AGENDA STAKEHOLDER SUBWORKGROUP MEETING Energy Subworkgroup Tuesday, March 31, 2020 9:30 a.m.

### **Energy Subworkgroup**

### Agenda

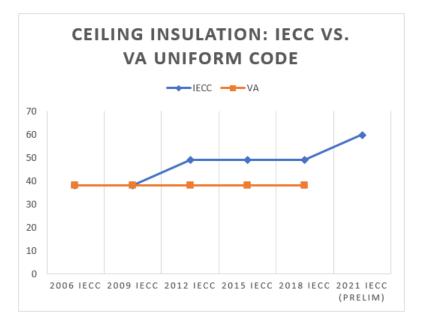
**Reason Statement:** The purpose of this proposal is to improve energy savings and increase homeowner comfort by adopting the ceiling insulation requirements of the 2018 IECC. Improving ceiling insulation from R-38 to R-49 will make Virginia's energy code consistent with insulation requirements that have been part of the 2012, 2015, and 2018 IECC.

Based on our analysis, we found that **homeowners will benefit from roughly \$10-\$14 annual energy cost savings as compared to a home built to Virginia's current energy code**. Using the U.S. Department of Energy's Residential Energy and Cost Analysis Methodology, we calculated the expected costs and savings associated with improving attic insulation from R-38 to R-49 for cities in three different regions of Virginia. The results, which are summarized below, show clear energy cost savings and low first cost in all three cities.

This analysis assumes attic insulation upgrades from R-38 to R-49. Calculations use the standard DOE prototype home information for a single-family home and costs from BEopt v.2.8. The complete DOE Residential Energy and Cost Analysis Methodology can be found

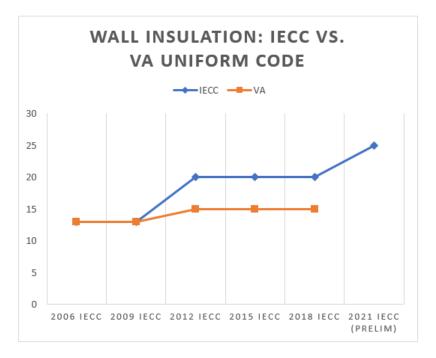
**Reason Statement:** The purpose of this proposal is to improve energy savings and increase homeowner comfort by adopting the wall insulation requirements of the 2018 IECC. Improving wall insulation from R-15 or 13+1 to R-20 or 13+5 will make Virginia's energy code consistent with insulation requirements that have been part of the 2012, 2015, and 2018 IECC.

Based on our analysis, we found that **homeowners will benefit from roughly \$78-\$103 annual energy cost savings as compared to a home built to Virginia's current energy code**. Using the U.S. Department of Energy's Residential Energy and Cost Analysis Methodology, we calculated the expected costs and savings associated with improving wall insulation from R-15 to R-20 for cities in three different regions of Virginia. The results, which are summarized below, show clear energy cost savings and low first cost in all three cities.
